Technical Service BULLETIN

M.I.L. "ON" DTC P0031, P0051, P2238, AND/OR P2241

'04 Highlander (V6)

**ENGINE
EG004-05**

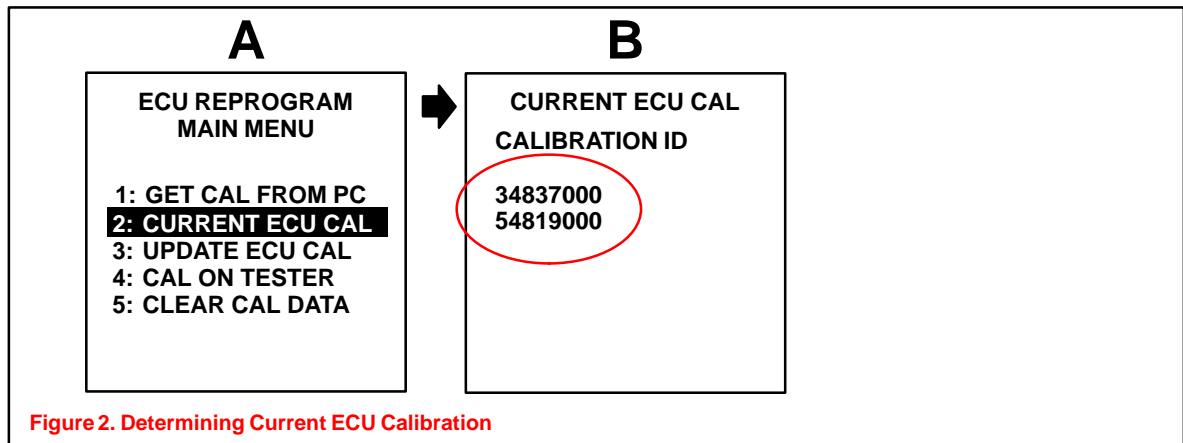
1. Replace both Bank 1, Sensor 1 and Bank 2, Sensor 1 air fuel ratio sensors.
2. Check for the Authorized Modifications Label affixed to the vehicle in the location shown in Figure 1. Confirm if ECM (PCM) calibration has been updated. If not the latest ECM (PCM) calibration — go to step 3.
